Addendum

SPRINGS AT FREMAUX TOWN CENTER
SLIDELL, LA

PHILLIPS JOB NUMBER 1333104
ISSUE DATE 07/07/14
DRAWN BY/CHECKED BY ATL/DEB
DRAWING TITLE UNIT 2GC FLOOR PLAN, ELEVATIONS & DTLs.
SHEET NUMBER A4.2GC

UNIT 3GC
FLOOR PLAN,
ELEVATIONS & DTLs.
 SHEET NUMBER

UNIT 2GC: POWER AND LIGHTING PLANS

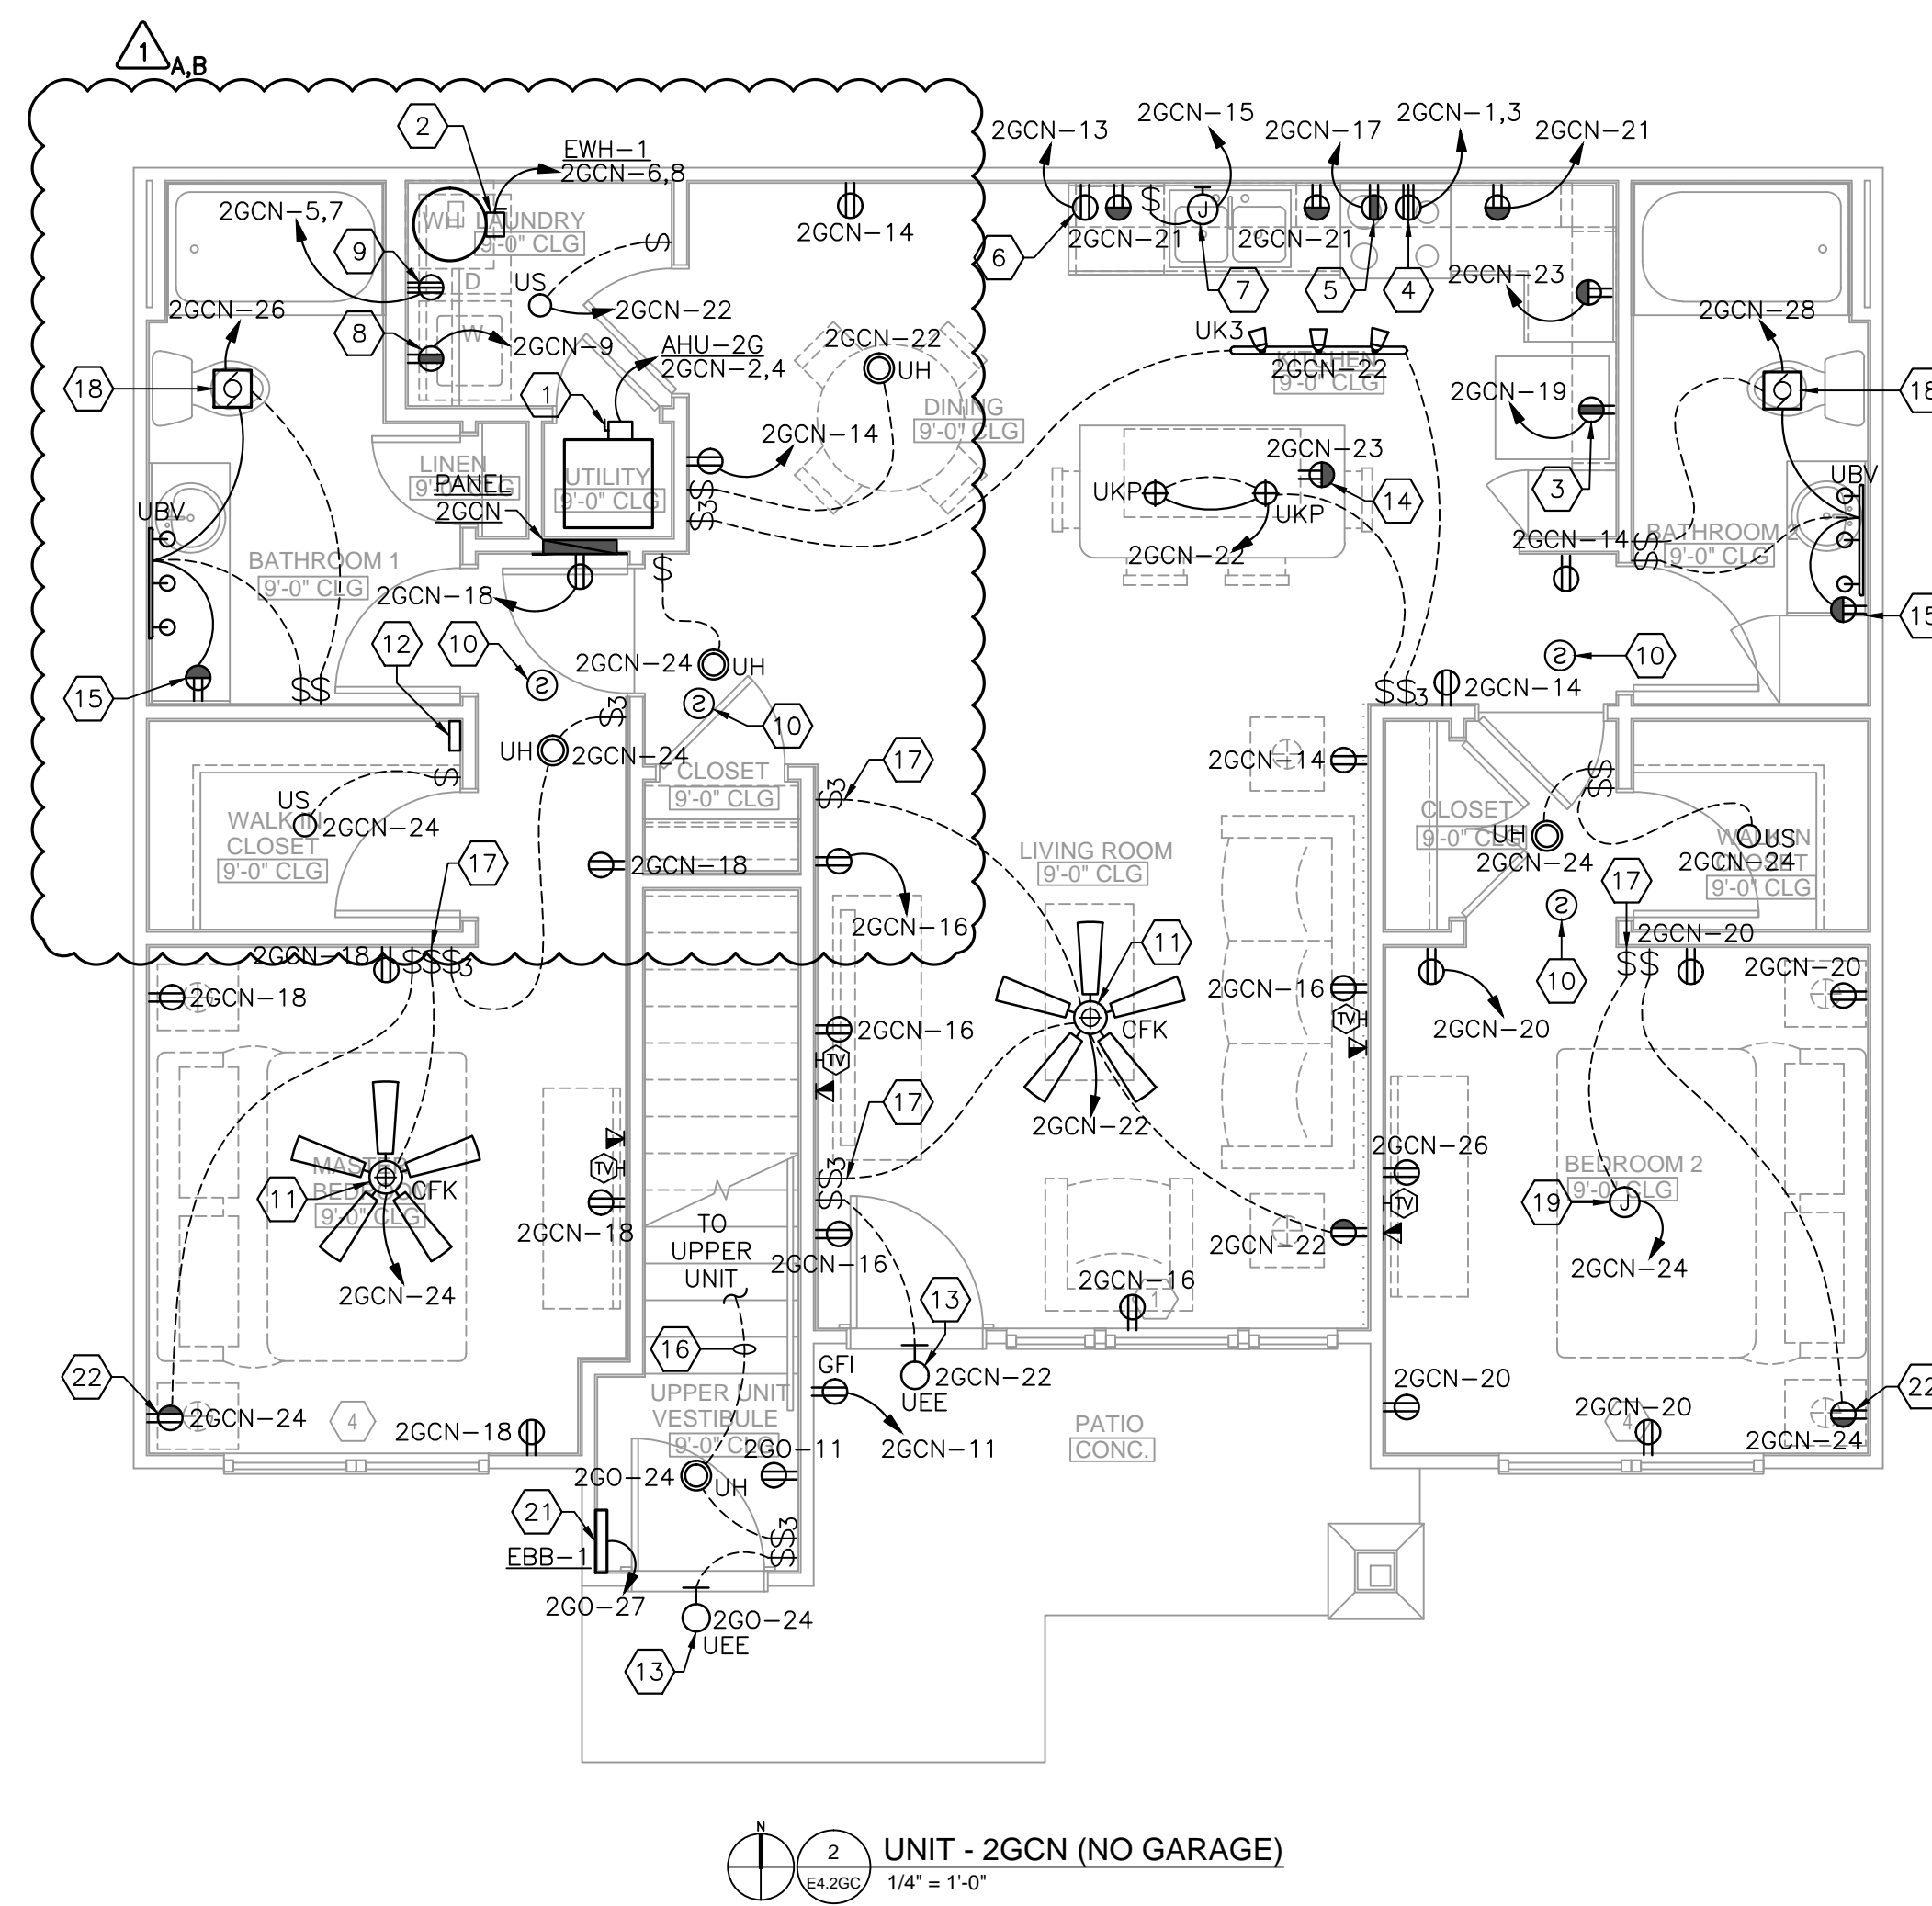
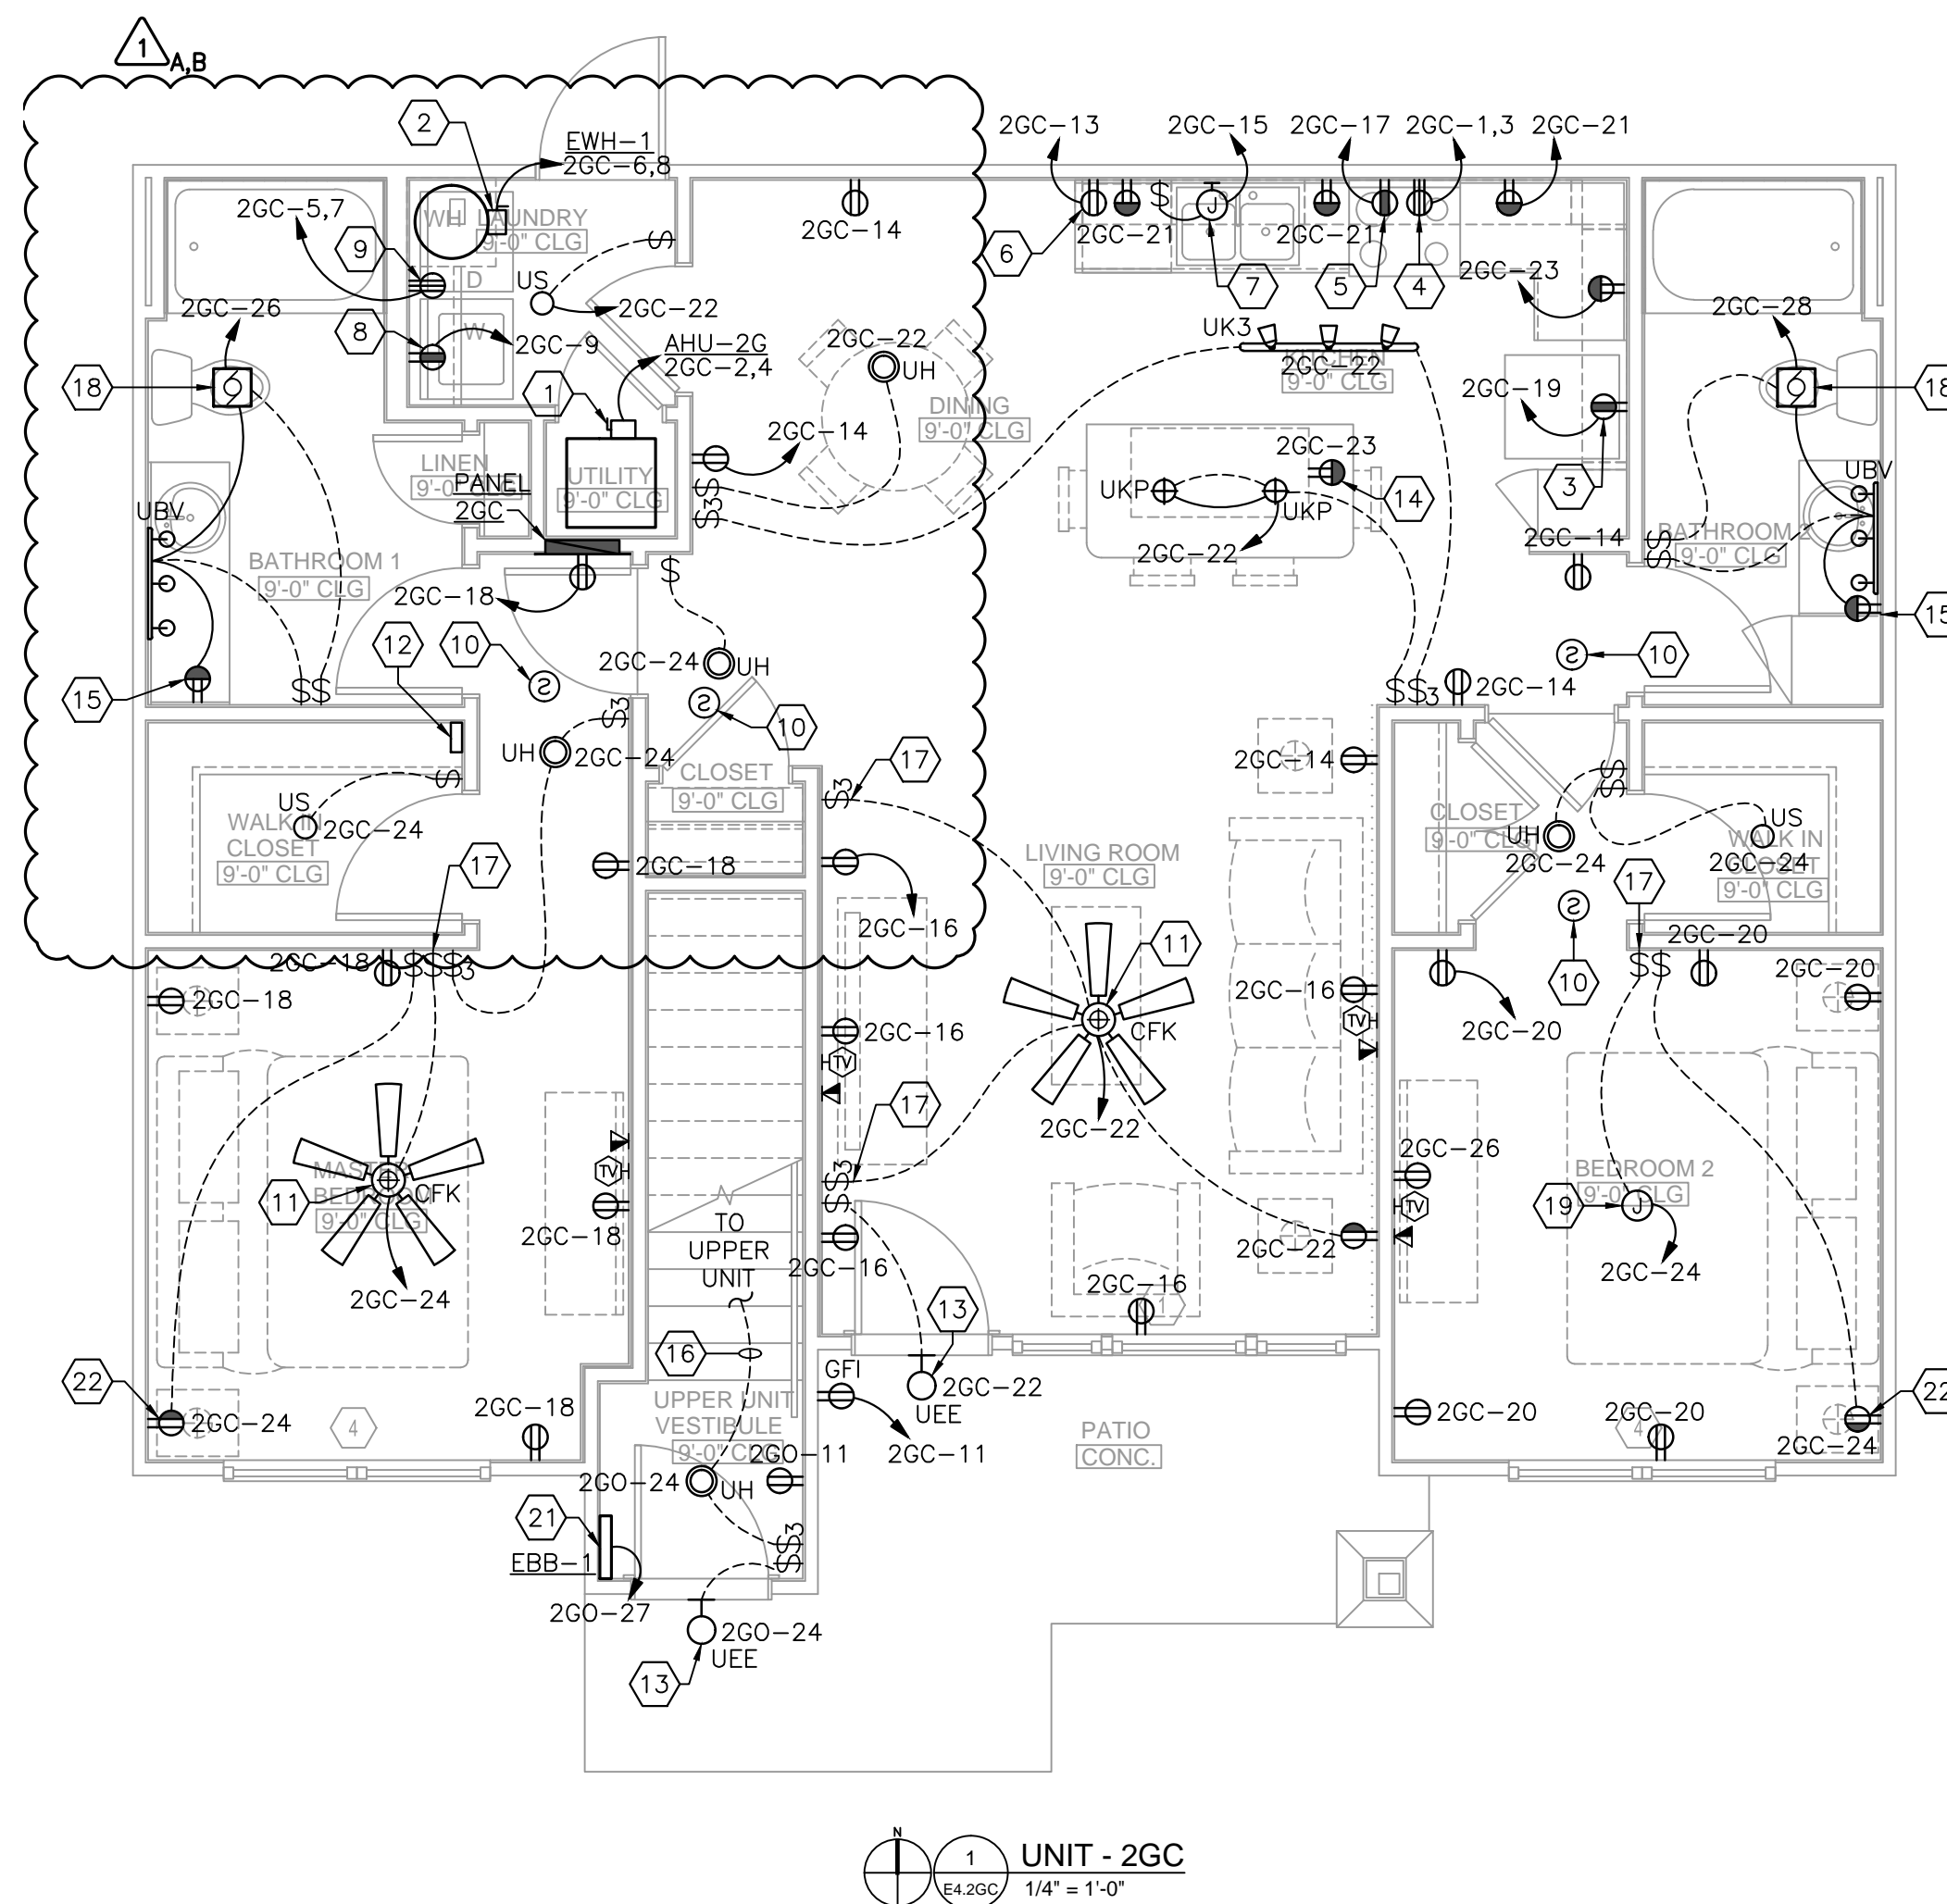
- A. UPDATED LIGHTING, RECEPTACLE, AND SWITCH LOCATIONS BASED ON ARCHITECT CHANGES.
- B. REMOVED RECEPTACLE(S) FROM DINING AND LAUNDRY.
